Office Action Summary

10/077,665

SMITH, GARRETT ANDREW

DETAILED ACTION

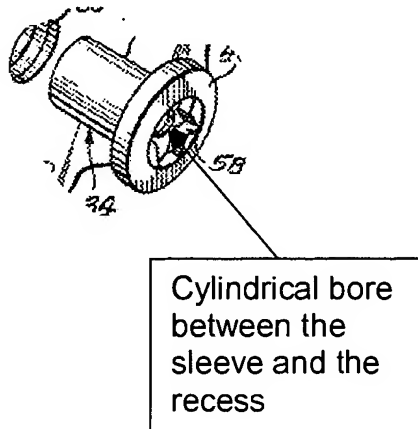
6. Applicant's arguments filed 12-24-2004 have been fully considered but they are not persuasive. Applicant contended that the bolt of Kirrish has a head with a tool interface means and the tool interface does not form part of the cylinder of the bolt. In response, in figure 1, it can be seen that the nut (34) has a cylindrical hole passing through the sleeve (50) and the head (48). The cylindrical hole has three sections; one section is in the sleeve, another is in the tool recess (58) of the head and a smaller section joining the hole in the sleeve and the tool recess. In addition, Kirrish clearly discloses that the nut comprise a head portion and a sleeve portion and a bore 52

extends through the sleeve, which means that the hole extends beyond the sleeve. See attached drawing section below.

Therefore, the rejection of WO(9308071) in view of Kirrish is proper. In addition Kirrish clear shows the nut as claimed.
